# PursoCal News-Letter

DataBase-2829

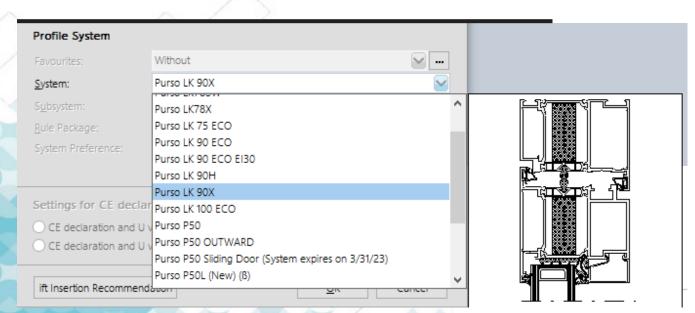
LK100eco fixed distance between drainage holes, from max. 800mm. ---> to max. 700mm.

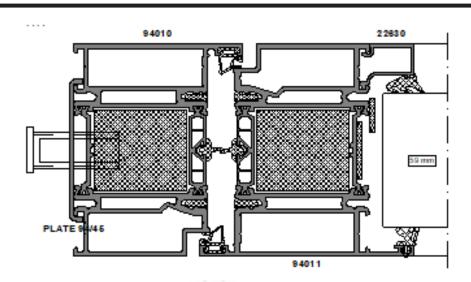
P94 adjufix AH38 + plate 94/45 in cross section.

LK90eco/LK90eco EI30 Adjufix machining added.

LK90eco/LK90eco EI30 Replaced adjufix AH38 to Adjufix WM38.

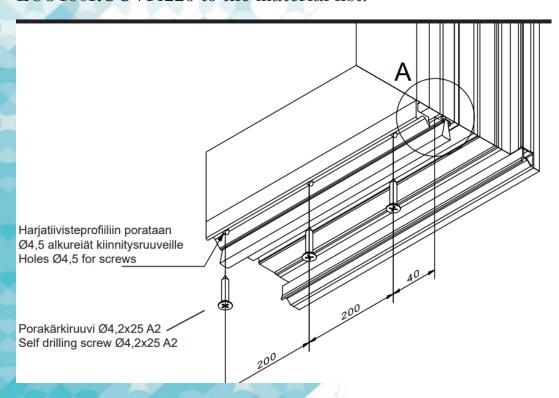
LK78X/SW for Brush profile 18538 fixation added screws ECO100RUUVI4225 to the material list.

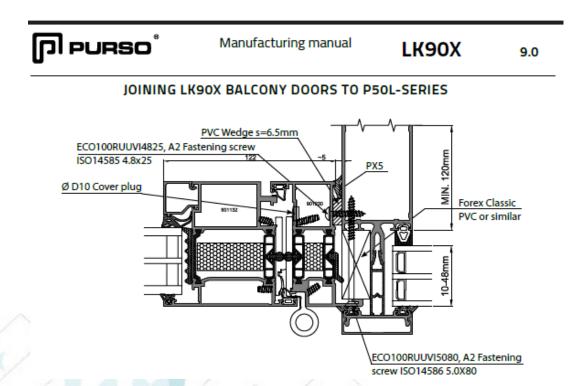
LK90X added Wall connection machining (optional) on profiles 901130 -901230 if doors fixated to facade. Instruction page 9.0, 9.1, 9.2.
